# JPARC Materials and Life Science Facility Technical Advisory Committee (N-TAC)

## *Report on the Fourth Meeting*

Held at JAEA Tokai Site  
Nov. 14 – 16, 2005

### ***Shutters – Mechanical Alignment***

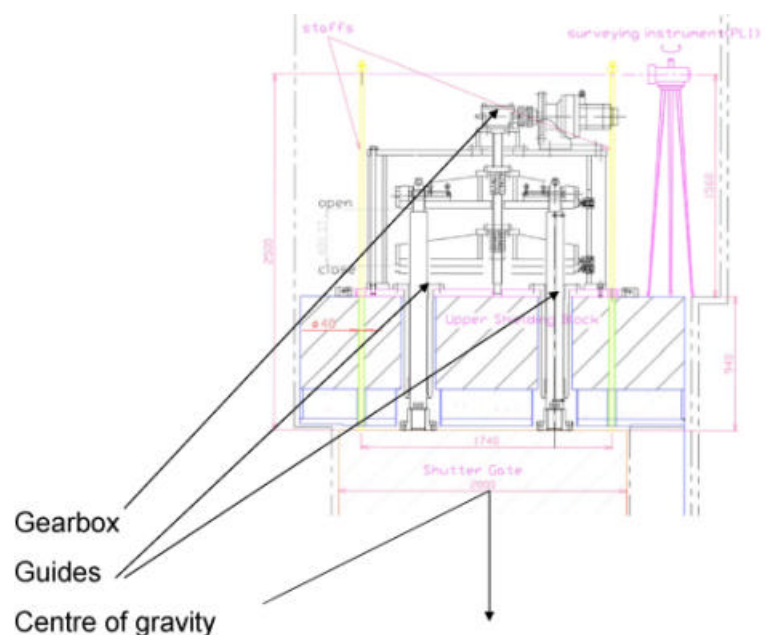
There is restricted space around the shutter lifting mechanisms and restricted access to the mechanical components.

The clearance between the shutter and the interstitial blocks is 20 mm. There seems to be nothing to prevent the shutter from touching the blocks particularly when the shutter twists from the torque reaction when the motor is started.

There are several fixed points in the shutter support system. These need to be aligned very precisely to avoid damage and excessive wear in the lifting system. It is most important that the shutter hangs freely. There will be a torque reaction when the motor starts. It is not clear in which component this force is absorbed. There is a danger of high loads on the fixed points (either the gear box or the guides) which may not be acceptable.

The Committee recommends that a simple mock-up of the area is constructed to test whether there is sufficient access for the work required at installation, maintenance and shutter removal.

The Committee recommends that the possibility of adding a simple guide system be considered.

The Committee recommends early operation of a prototype, or one of the production systems, to investigate the operability of the shutter system.
